HARD COPY + SKETCH
from
Susan Hughes
51 Reeves Way

49 REEVES WAY WOKINGHAM RG41 2PS

Application Number: 260063

PROPOSED ERECTION OF A SINGLE STOREY REAR EXTENSION FOLLOWING DEMOLITION OF THE EXISTING CONSERVATORY, PLUS CHANGES TO FENESTRATION

Side Views

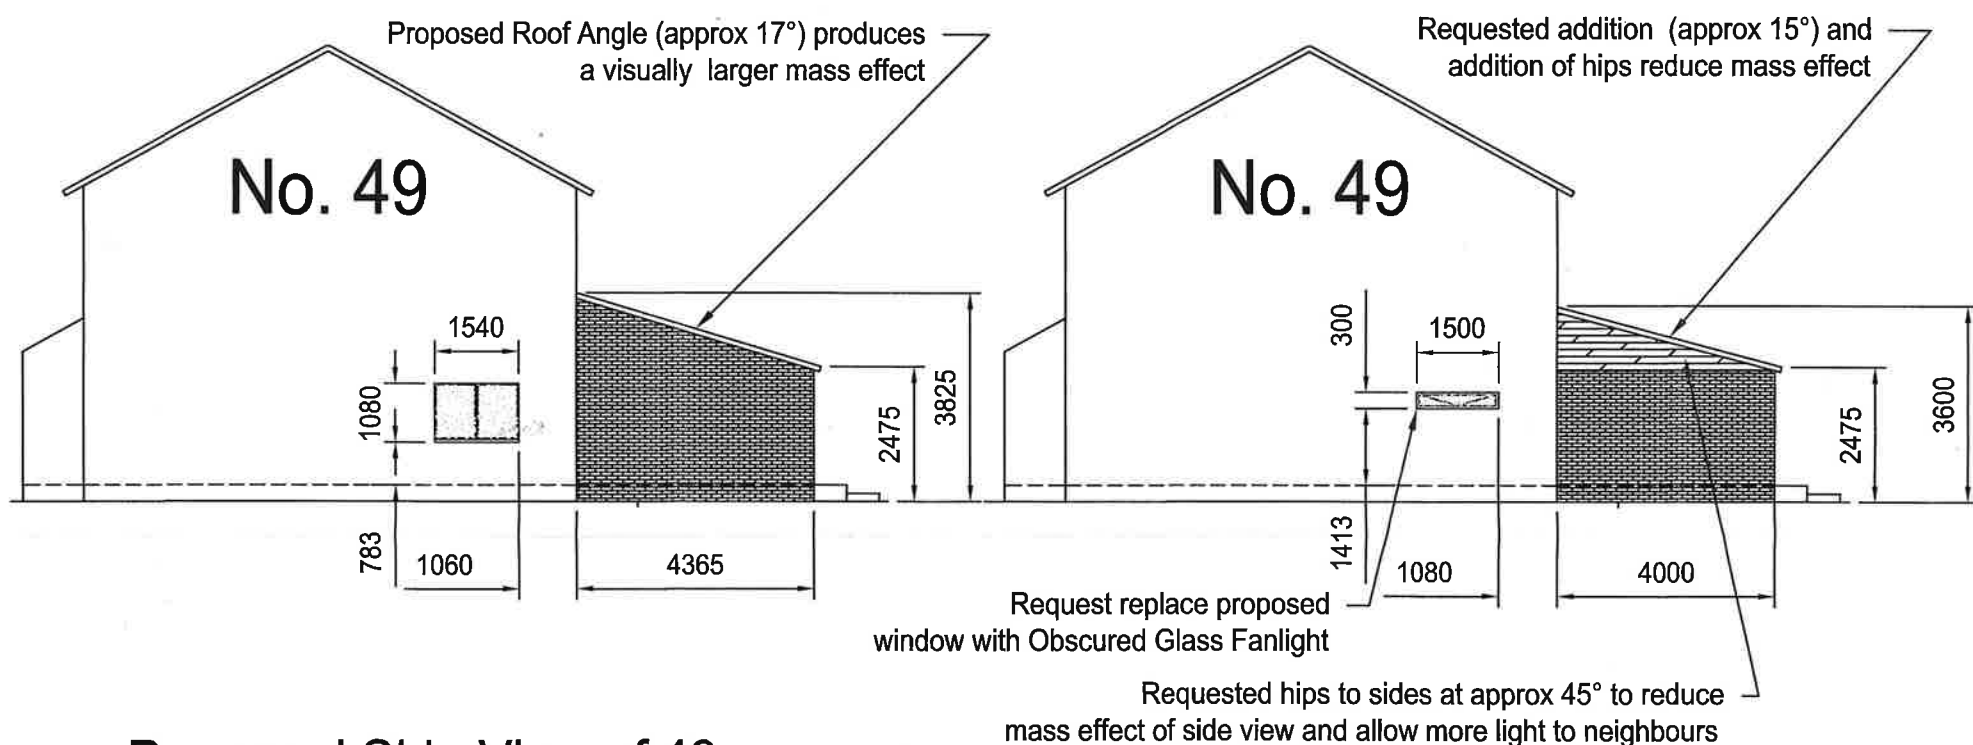
The proposed extension, which is the subject of part of this application, is of a large area and extends the whole width of the existing house. It will therefore extend close to our boundary fence and will be overbearing in appearance from our adjacent property as we would be looking out on a large plain brick wall from our dining room window. Also the design is one with a single pitch roof with two plain brick walls at either side that would slope up to height just below the existing first floor windows.

The proposed extension is 4.365 metres in length from the existing rear wall of 49 Reeves Way and this is in contravention of the Borough's Design Guide which states "Rear extensions should not project more than four metres from the main wall where they are close to a side boundary". The distance from the wall of the proposed new extension to the side boundary of the property (the fenceline between 49 Reeves Way and 51 Reeves Way) is only 1.04 metres.

I would therefore prefer and suggest that the extension be only the maximum of 4 metres and that it should have a hipped roof design, where there are 3 pitches of roofline as shown on the diagram attached to the hardcopy of this document. (Which will be delivered by hand to the Council's offices, prior to the deadline for comments.) If the roof is sloped in from both sides, as well as the rear facing slope (ie 3 sides to the roof pitch), it would help to mitigate some of my concerns. This would result in the new side brick wall being lower in height along its length with a small side pitched roof sloping away from our property. This would be much less bulky and overbearing in appearance. This hipped style roof would also match the shape of the existing rear extension at 16 Crail Close (the property immediately to the rear of 49 Reeves Way and in direct view of this property) as well as the existing single storey conservatory/extension to the rear of 47 Reeves Way, making the proposed new extension to 49 Reeves Way more aesthetic to the eye and in keeping with the neighbouring area.

Also a much shallower pitch of roof (reducing the height of the extension where it meets the existing rear wall of 49 Reeves Way) would reduce the side view effect from our property.

I would request that the extension be set back from the house edge at a similar distance to the existing conservatory at 49 Reeves Way which will be removed. This would again reduce the overbearing impact of the extension.

Rear Views

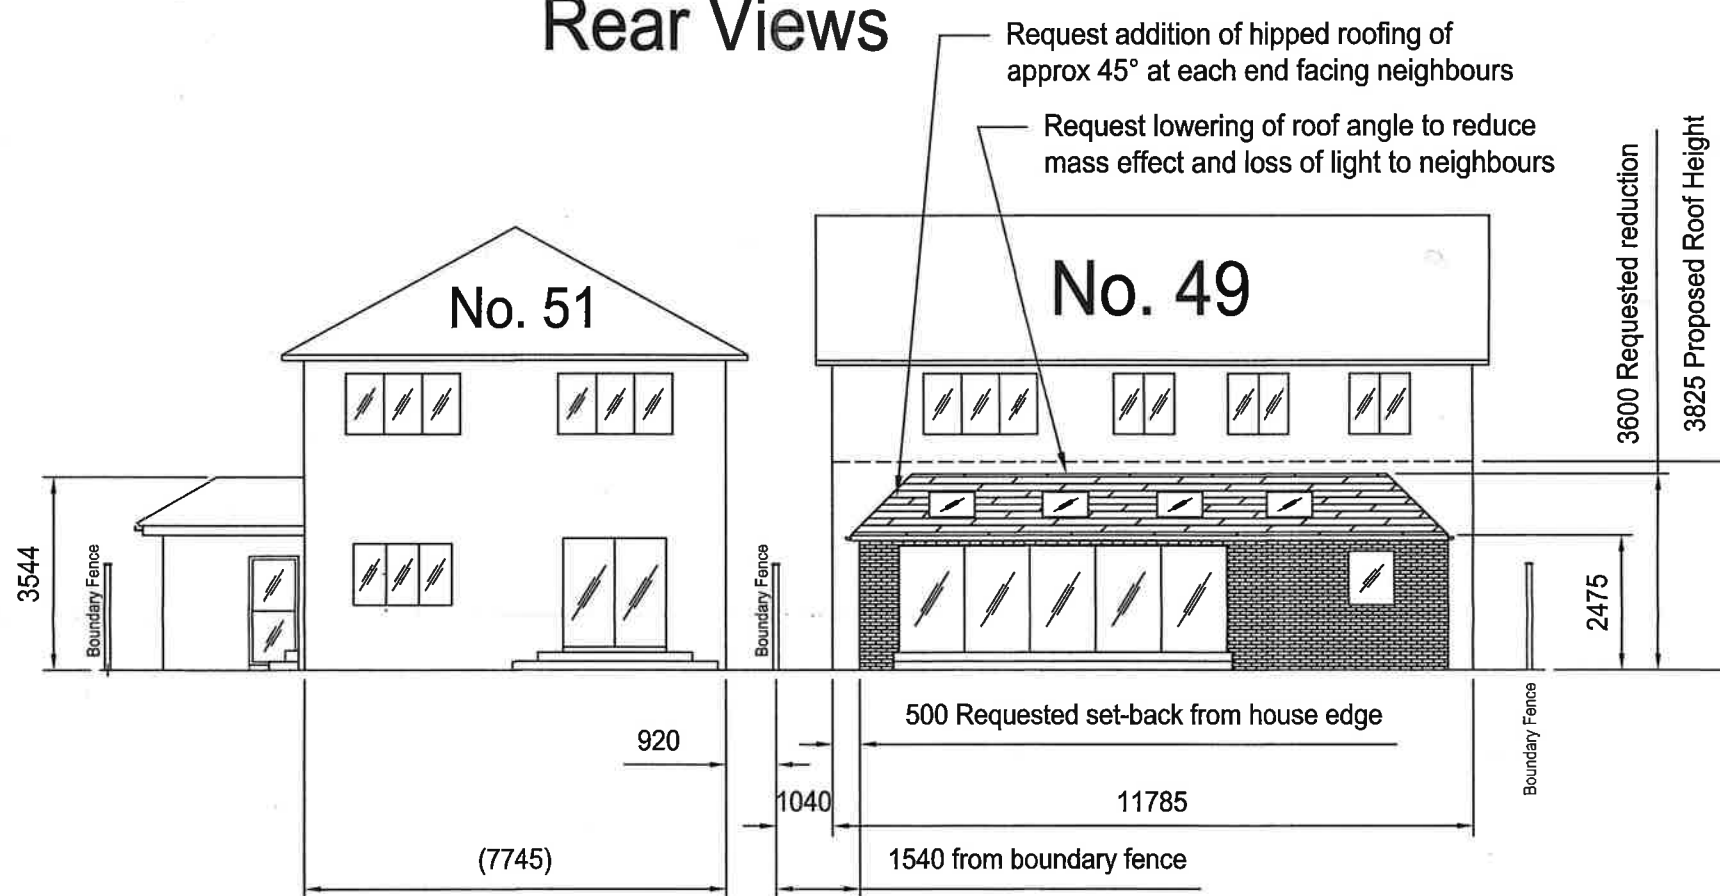
therefore that a hipped roof style at a lower pitch would be more in keeping with the neighbouring properties because of the hipped style roof of the existing large rear extension at 16 Crail Close (the property immediately to the rear of 49 Reeves Way) and the hipped style roof of the existing rear extension at 47 Reeves Way.
